# PERMIT

SEWAGE DISPOSAL SYSTEM  
HOWARD COUNTY HEALTH DEPARTMENT  
BUREAU OF ENVIRONMENTAL HEALTH  
410-313-2640

P 515957-A

SUBDIVISION Cattail Ridge LOT NUMBER 10 ADDRESS 3612 Clear Drive Court

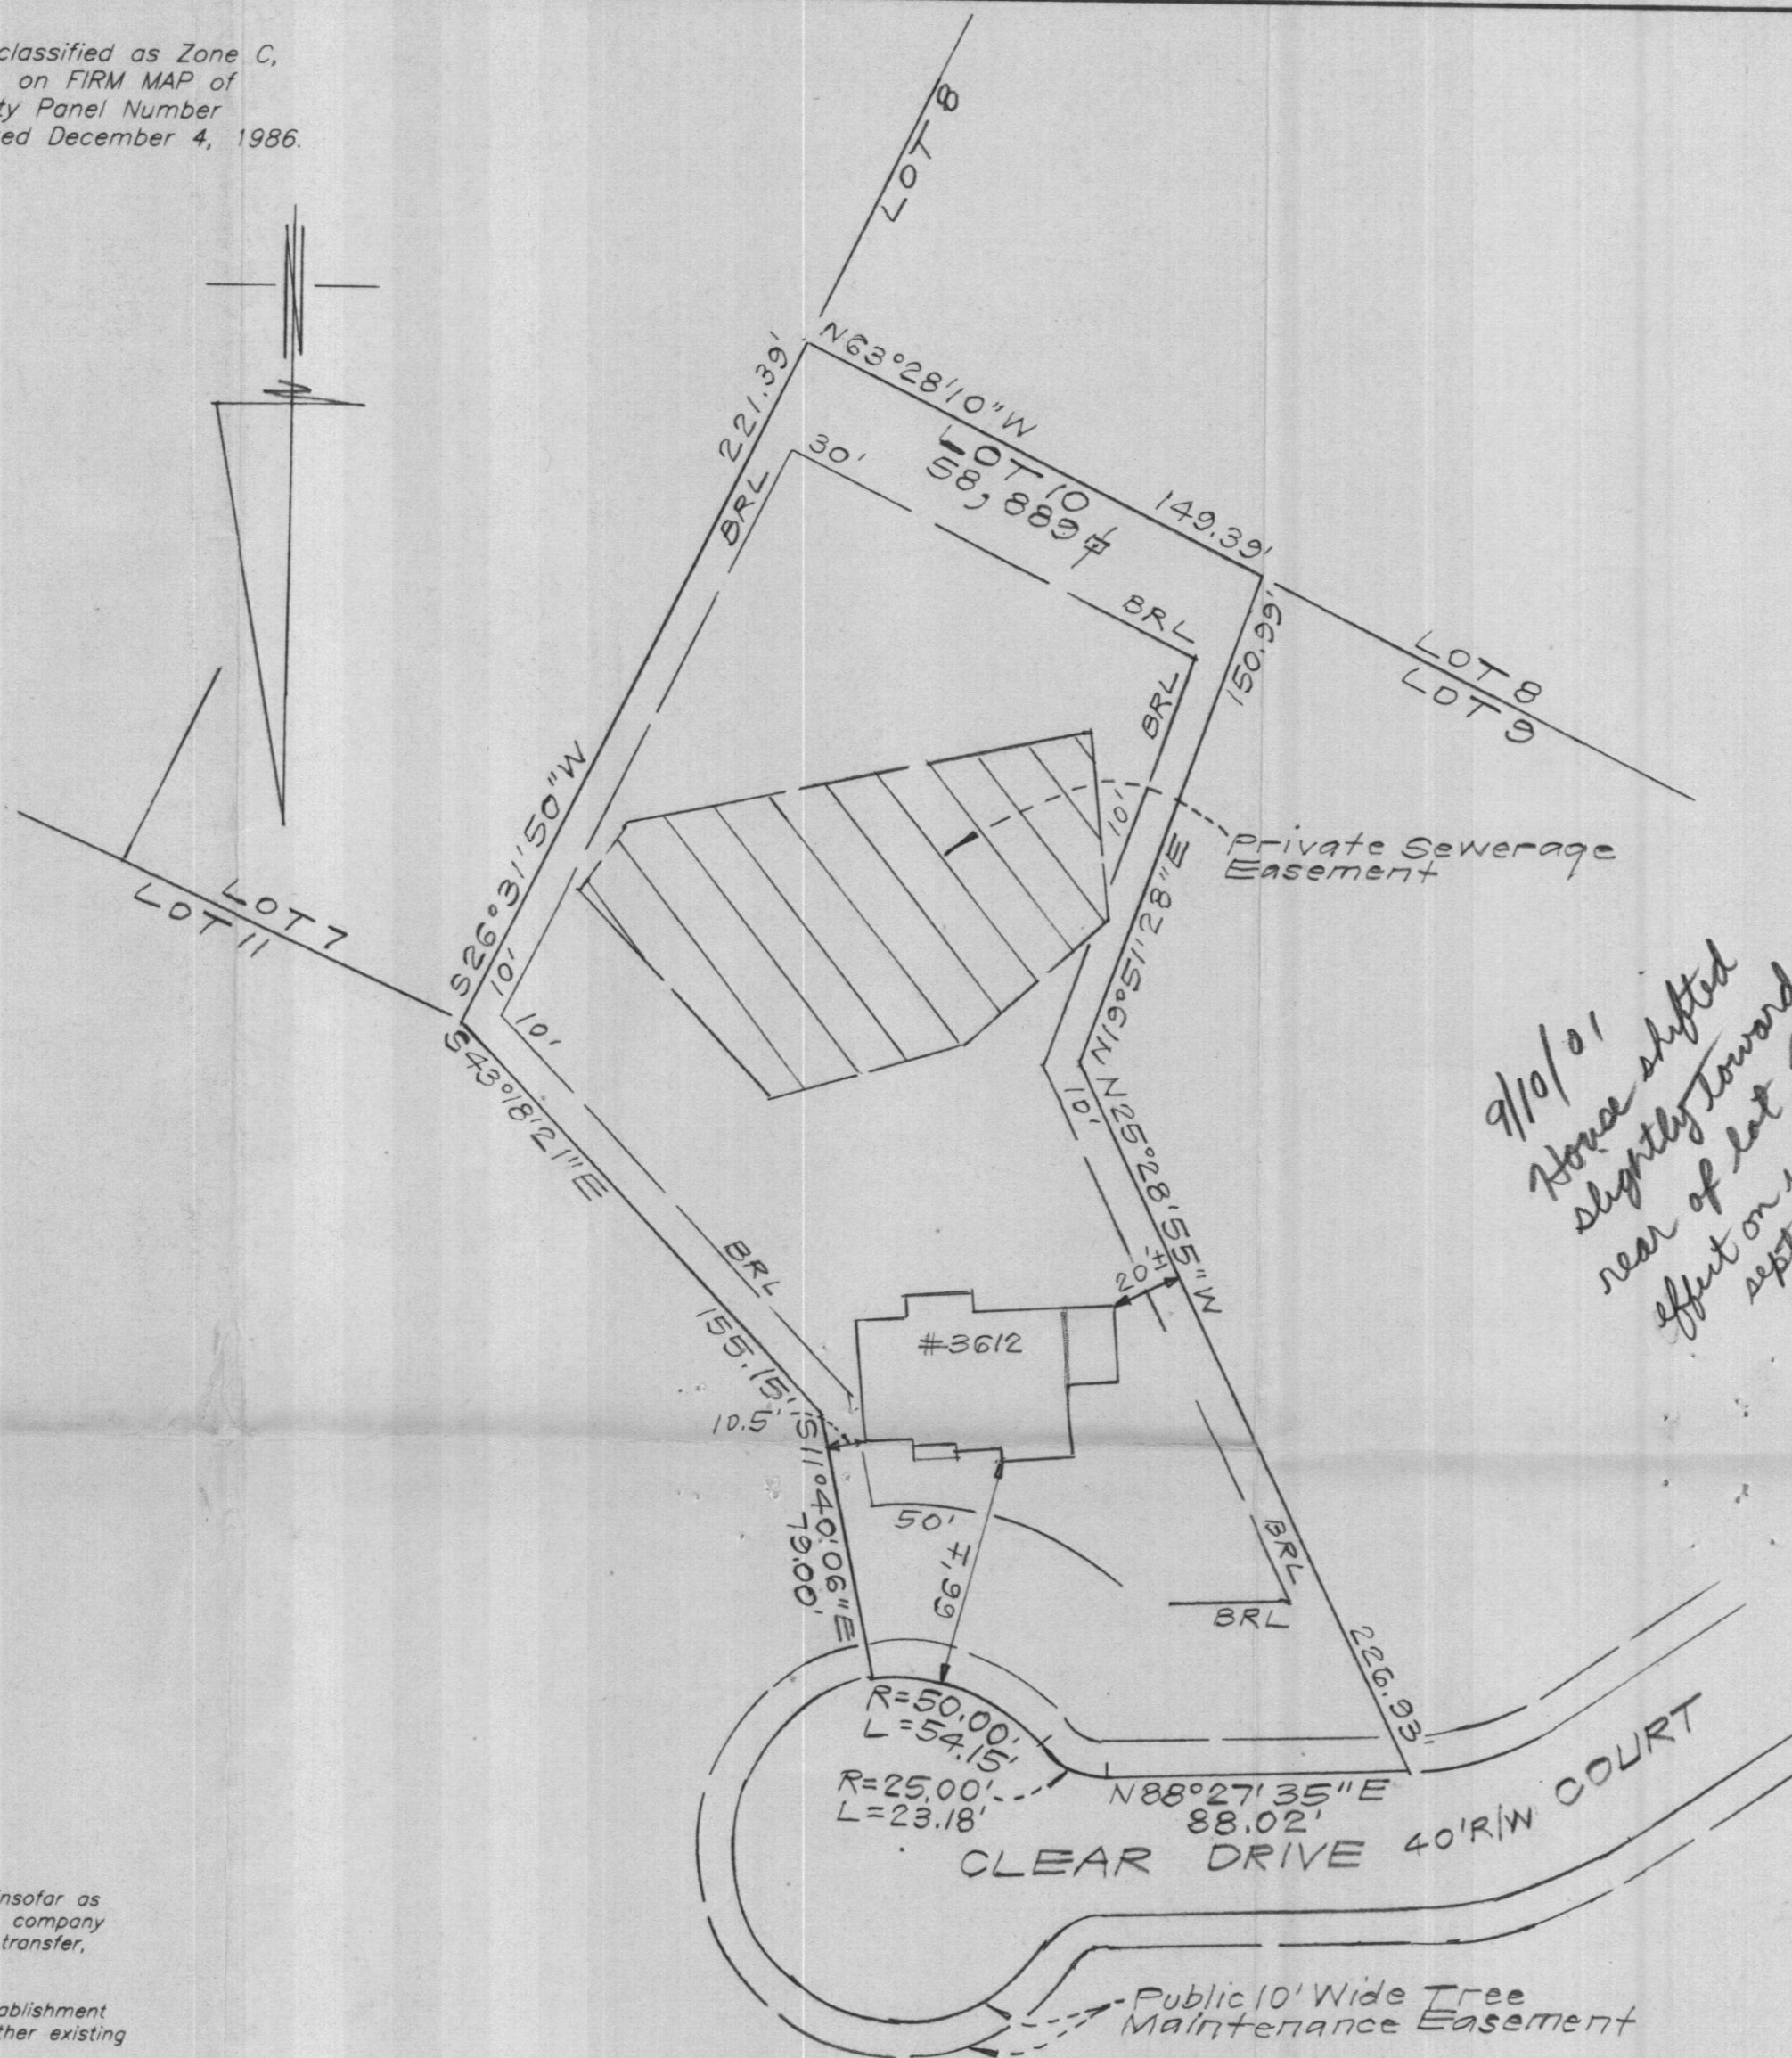
PRE-CONSTRUCTION INSPECTION: Septic Tank location change due to Builder's coming out of house on opposite side than shown in BP Plans. Layout of Trenches on contour is OK. RP 9/18/01

INSPECTION COMMENTS: Septic Tank Set, location change OK, OK to proceed RP 9/18/01

Baffle on Rear side, House Connection OK RP 9/18/01

9/19/01 OK TO COVER ALL (MR)

9/19/01 WPI-ALL OK (MR)

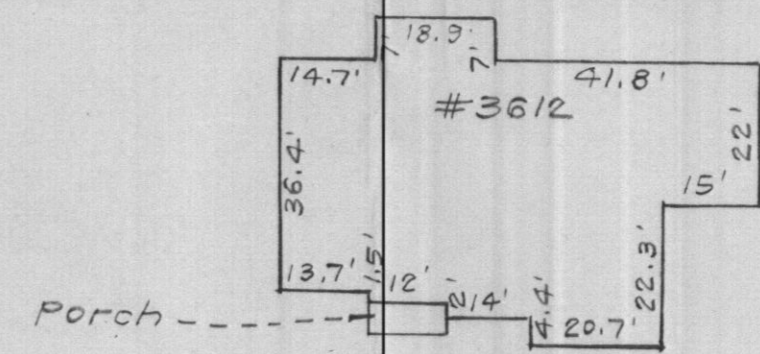
9/10/01  
Fence shifted  
slightly towards  
rear of lot. No  
effect on well or  
septic. 0.2'  
(BB)
